SUNDRY NOTICES AND REPORTS ON WELLS
Do not use this form for proposals to drill or to re-enter an abandoned well. Use form 3160-3 (APD) for such proposals.

NEW WELLHEAD

MEAN GREEN 23 FED COM 1H & MEAN GREEN 26 FED COM 1H

CONDITIONS OF APPROVAL

SURFACE WELLHEAD LAYOUT
UNIHEAD, UH-1, SOW,
DEVON ENERGY, ODESSA

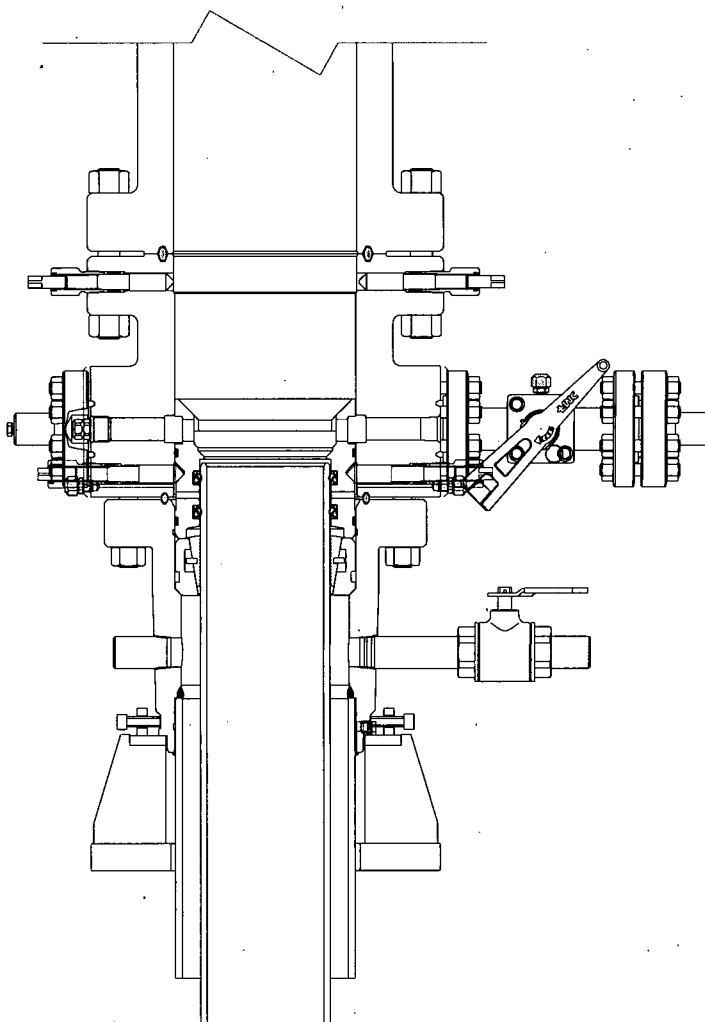
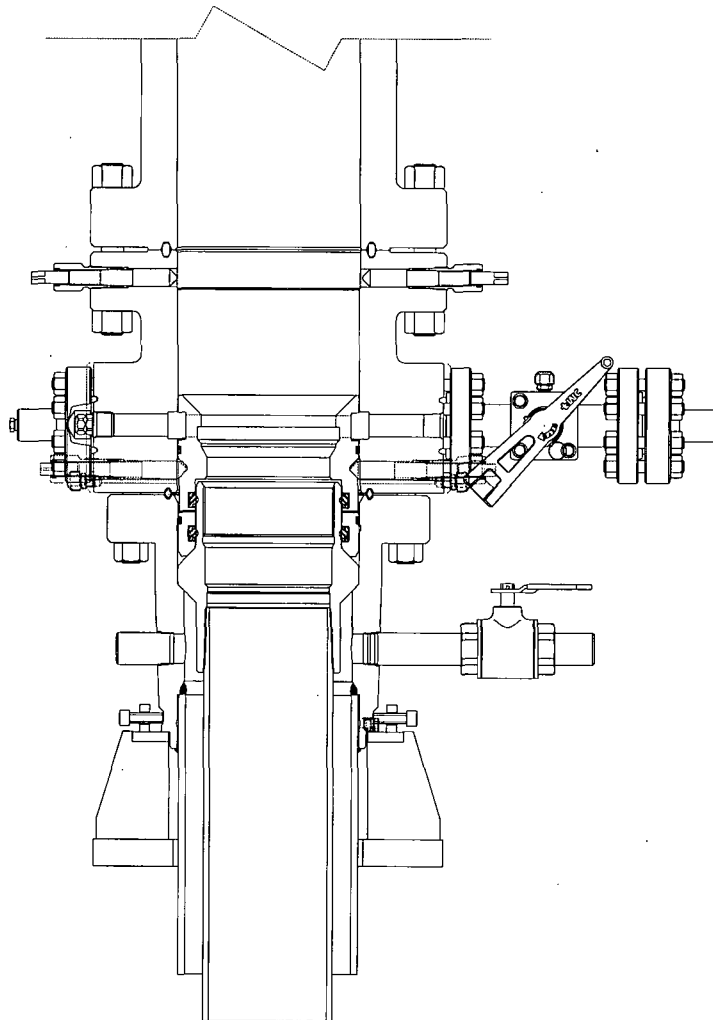
Devon Energy Production Co., L.P. respectfully proposes using a multi-bowl wellhead assembly (FMC Uni-head) per the attached.

Devon Energy Production Co., L.P. respectfully proposes using a multi-bowl wellhead assembly (FMC Uni-head). This assembly will only be tested when installed on the surface casing. Minimum working pressure of the blowout preventer (BOP) and related equipment (BOPE) required for drilling below the surface casing shoe shall be 3000 (3M) psi.

After running the 9-5/8" intermediate casing with a mandrel hanger, the 13-5/8" BOP/BOPE system with a minimum rating of 3M will already be installed on the FMC Uni-head. Please find attached the wellhead schematic.

- 1. Operator has proposed a multi-bowl wellhead assembly. This assembly will only be tested when installed on the surface casing. Minimum working pressure of the blowout preventer (BOP) and related equipment (BOPE) required for drilling below the surface casing shoe shall be 3000 (3M) psi.**

- a. Wellhead shall be installed by manufacturer's representatives, submit documentation with subsequent sundry.**
 - b. If the welding is performed by a third party, the manufacturer's representative shall monitor the temperature to verify that it does not exceed the maximum temperature of the seal.**

- c. Manufacturer representative shall install the test plug for the initial BOP test.**
 - d. Operator shall perform the intermediate casing integrity test to 70 % of the casing burst. This will test the multi-bowl seals.**

- e. If the cement does not circulate and one inch operations would have been possible with a standard wellhead, the well head shall be cut off, cementing operations performed and another wellhead installed.**
